MINUTES
Lancaster County Planning Commission
July 16, 2024 2023 6:00 p.m.
AMENDED

b. SD-2023-1869 Barberville Commercial Preliminary Plat

Re: Comments on SD-2023-1869, Barberville Commercial Project

Topography

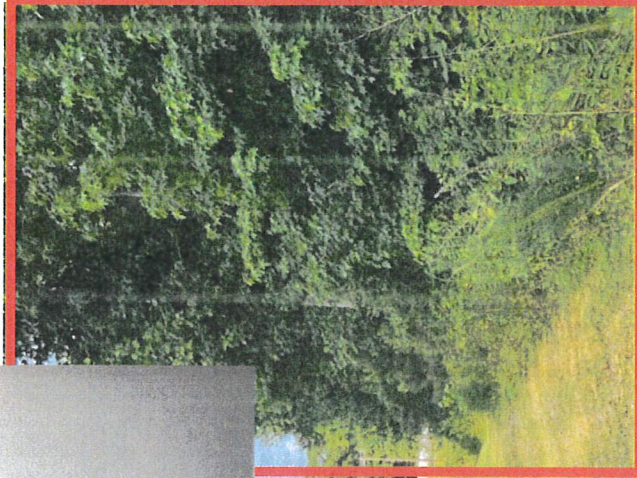
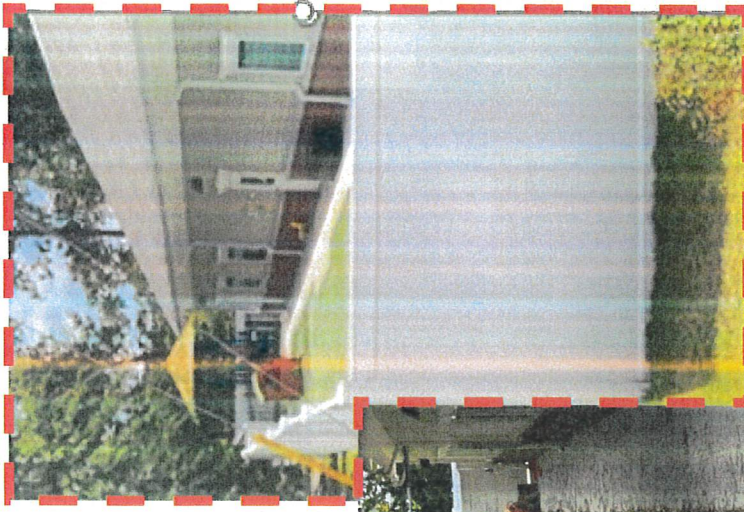
Neighbor's Adjacent Property
Post Development
Assuming current contract

Their newest proposal

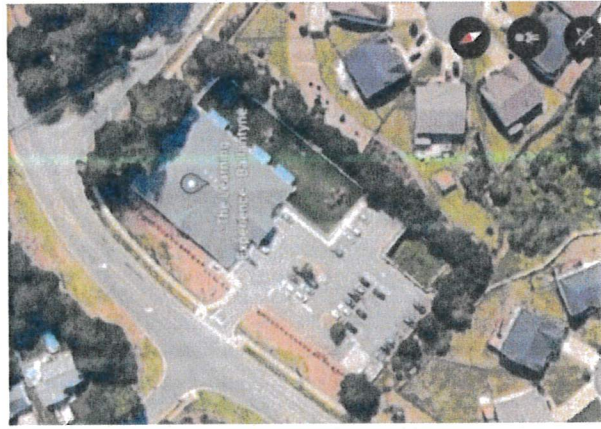
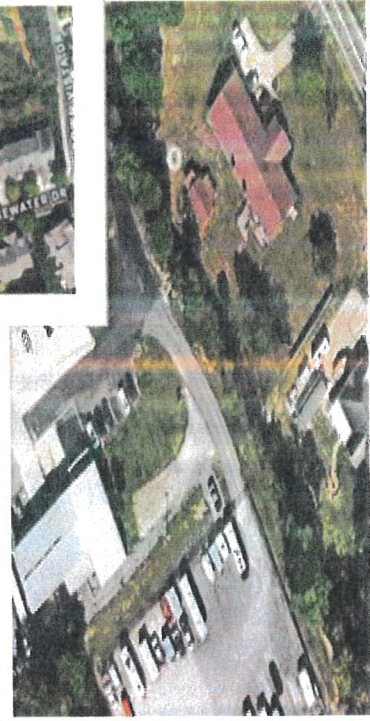
Equates eliminates any separation that we expected to maintain and commandeers our neighborhood for overflow parking

* According to developer the yellow is what we are to expect from a clearing and replanting
